LANDMARKS COMMISSION

Summary: Historic Review of Exterior Alterations to enclose a rear area of house and move rear door to align with the rear east wall and Historic Review of Substitute Materials for the replacement of three windows and the aluminum siding of the building located at 244 6th Avenue SE. (Project Planner – Alyssa Schrems alyssa.schrems@albanyoregon.gov)

Historic Review of Exterior Alterations and Substitute Materials

HI-05-25

*Existing Metal Siding
Reveal – 8 "*

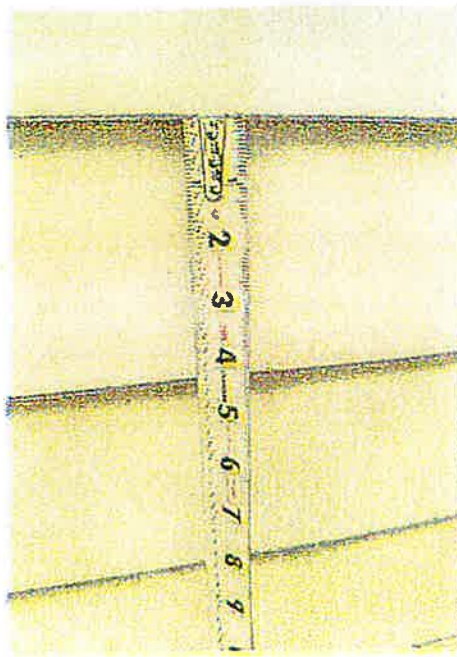
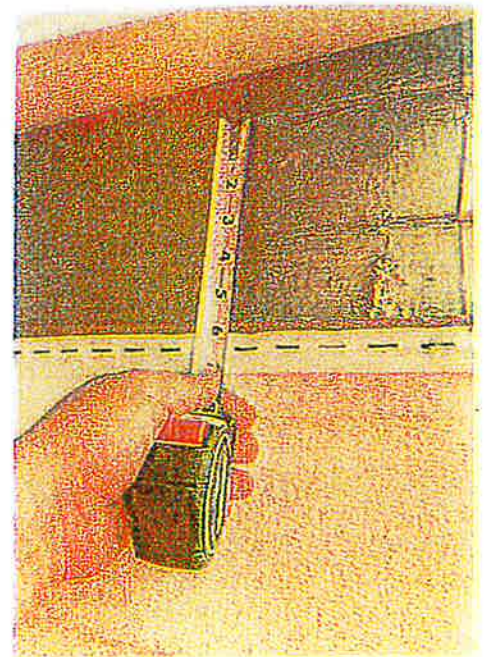
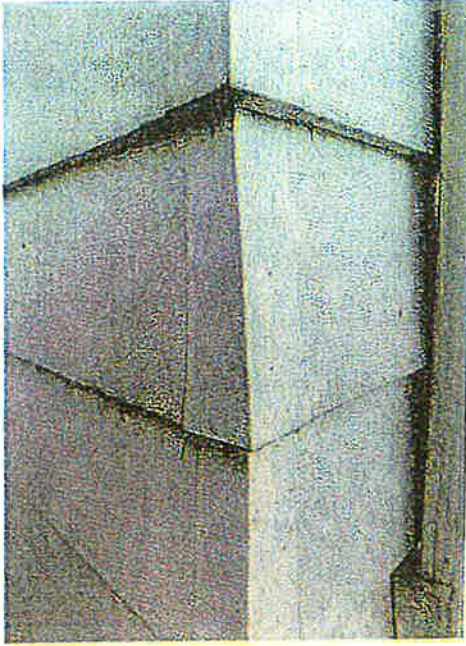
3. Request to show the reveal of the siding on the existing house and existing garage.

The garage building received Final Review from the Building Department on October 11, 2017. The existing siding reveal on the house is 8 inches. The existing siding reveal on the garage siding is 4 inches. The original wood siding reveal under the existing exposed siding on the house is 3 ½ inches.

Existing House Corner Trim

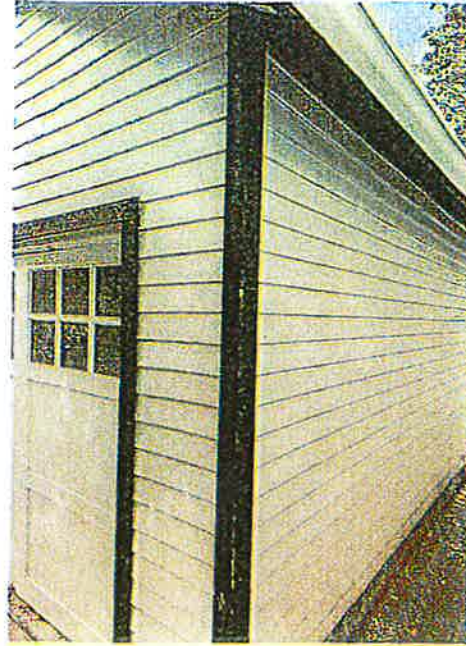
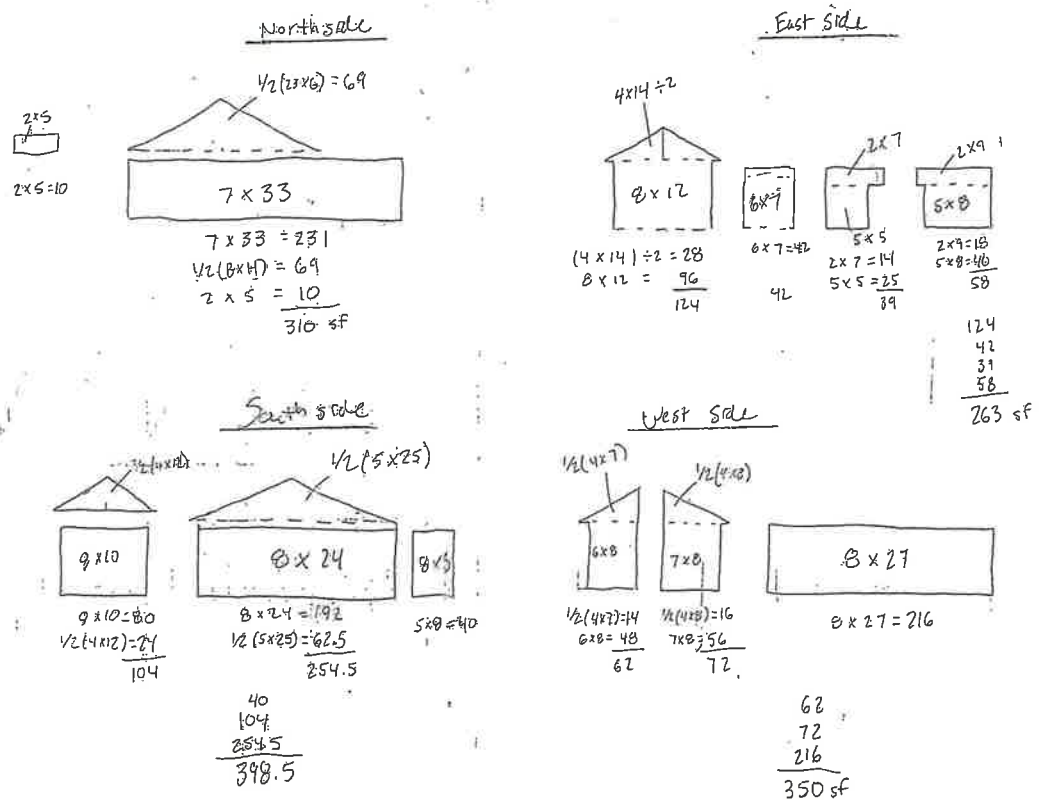
4. Request to show what the corner trim on the existing house and the existing garage look like.
